May 20, 1996
LIC-96-0072

SUBJECT: Additional Information to Assist Closure of NRR Staff Review of Fort Calhoun Nuclear Plant Individual Plant Examination (IPE) Submittal (TAC No. M74412)

Clarification of HRA Issues
Fort Calhoun Station Individual Plant Examination

Figure B-1. FESD for long-term recovery action.

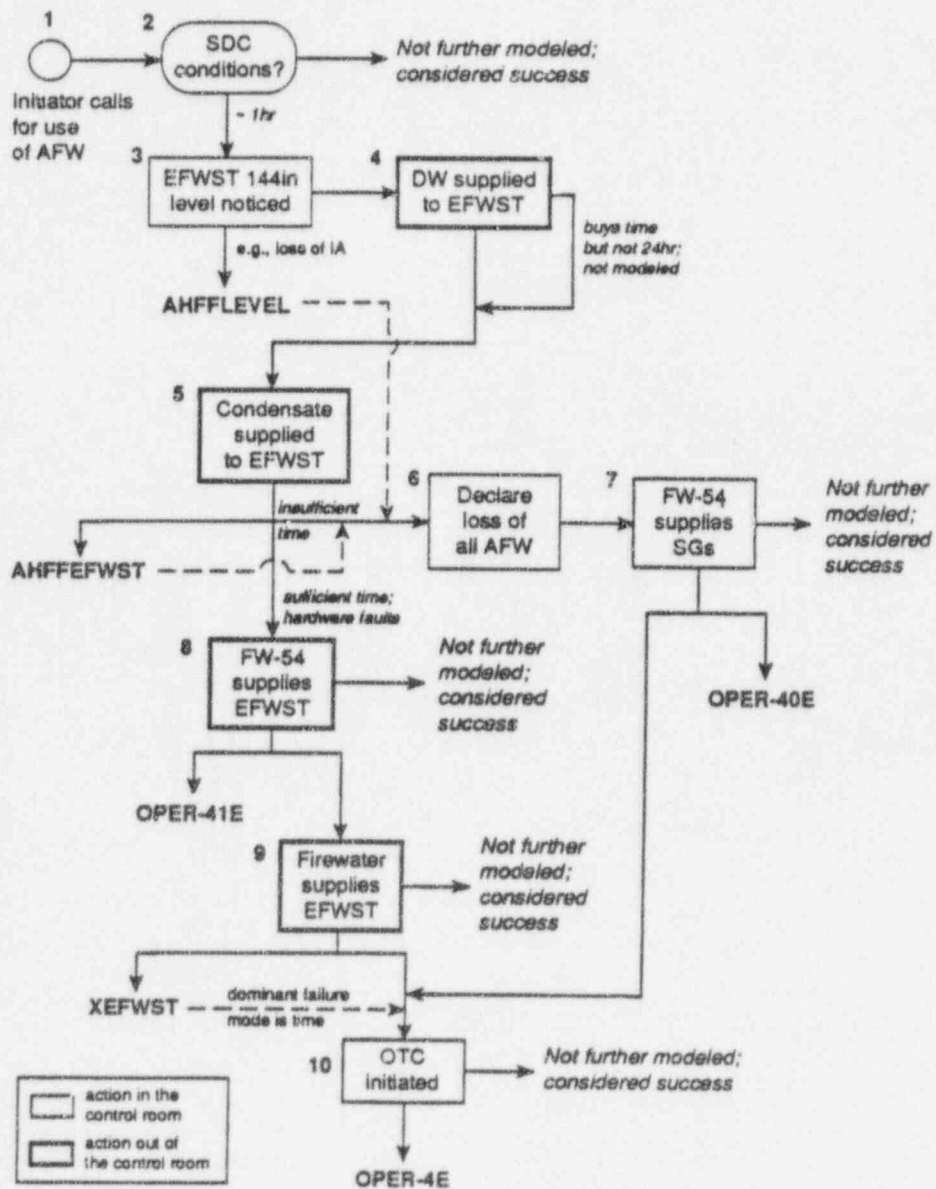
Lack of documentation/rules for the HRA process may limit usefulness of the IPE for future plant configuration or licensing changes, especially if the previous expertise is unavailable.

HFEs are identified in the system/event modeling effort or as part of the recovery analysis. Typically they are identified as a natural part of the fault tree/event tree modeling for sequences. Sometimes a special depiction of an event and its contingencies is made in a functional event sequence diagram (FESD). Figure B-1 in the HRA notebook is an example. This figure is included on Page 6.
